Planning Officer's Report – LDCA JUNE 2021

APPLICATION	2021/34 – Installation of Photovoltaic Panels
PERMISSION SOUGHT	Permission in Full
REGISTERED	9 th April 2021
APPLICANT	W.A. Thorpe & Sons Ltd
PARCEL	JT040033
LOCALITY	Thorpe's Warehouse, Ex Paramount Cinema, Jamestown
ZONE	Intermediate
CONSERVATION AREA	Jamestown Conservation Area
CURRENT USE	Warehouse
PUBLICITY	The application was advertised as follows: <ul style="list-style-type: none">▪ Independent Newspaper on 16th April 2021▪ A site notice displayed in accordance with Regulations.
EXPIRY	30 th April 2021
REPRESENTATIONS	None Received
DECISION ROUTE	Delegated / LDCA / EXCO

Diagram 2: Initial Submission – Layout of the Panels

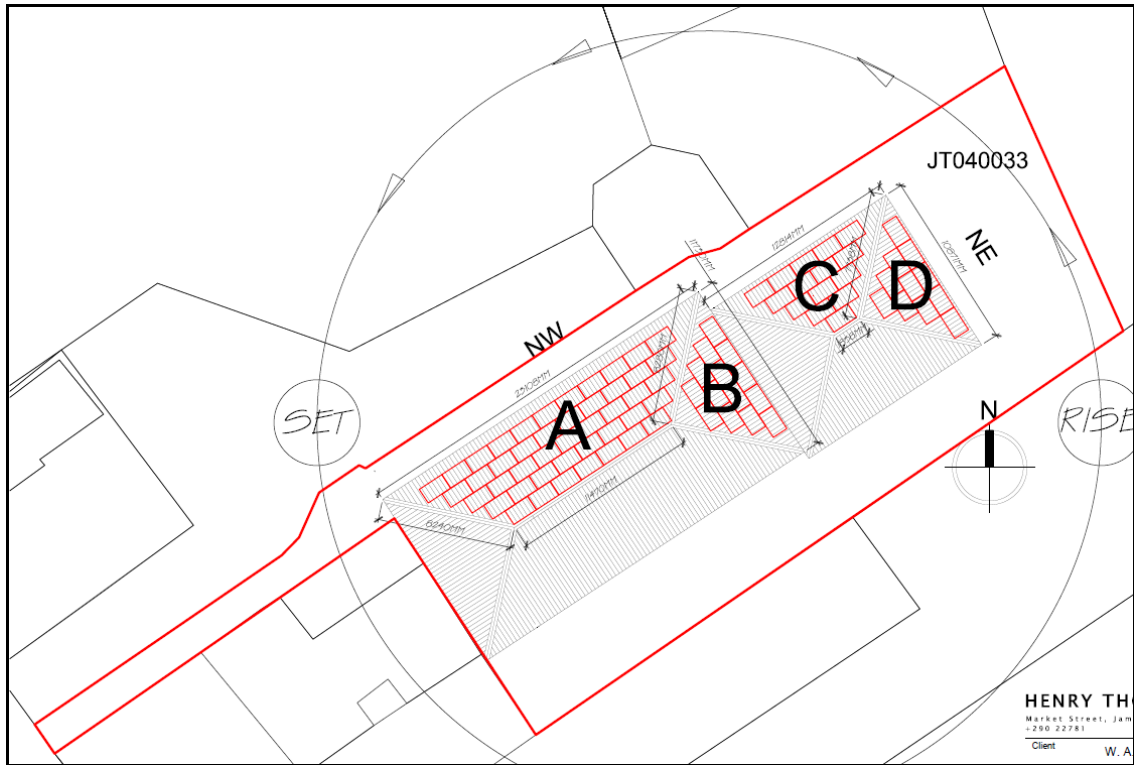
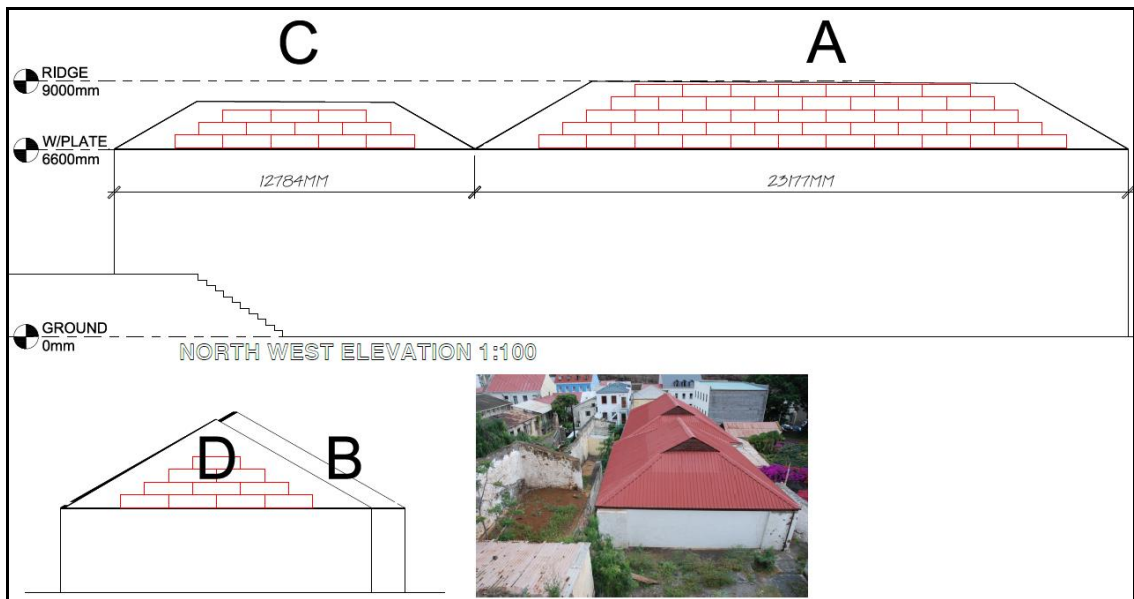
- proposed array of PV panels will be prominent on the southern side of the Castle Gardens and also prominent from the Grand Parade and as such, there is strong likelihood of the panels creating an adverse effect on the conservation area;

- advises that planning office give full consideration to the appearance and layout of the panels and to apply guidelines for their design as available elsewhere; and

- guidelines indicate that proposals may do less harm if there are fewer panels with more roof exposed around the perimeter than if a square ended rectangular pattern is adopted instead of the staggered design currently proposed.'

Having considered the initial submission as indicated in diagrams 2, the layout of the panels was deemed un-acceptable as the panels overpowered the roof visually. As a result of this, the Planning Officer negotiated a revised scheme with applicant and a revised proposal was submitted for consideration with a more symmetrical design, which has reduced the amount of coverage to allow for the perimeter of the roof to be exposed.

Officers Response – In assessing this proposal as well as the representation received, it is considered that the panels will not be prominent from the Grand Parade, however will inevitably be more visible from the Castle Gardens. The intention to stagger the panels are beneficial for the applicant as it ensures the roof space can be fully utilised, thereby maximising the number of panels to be installed. However the officers are of the view that where the layout and arrangement of the panels are staggered, the roof surface will become over developed and therefore will have considerable visual impact. Following discussions with the applicant on the proposed design, layout and number of panels to be installed, the applicant has submitted an amended design.
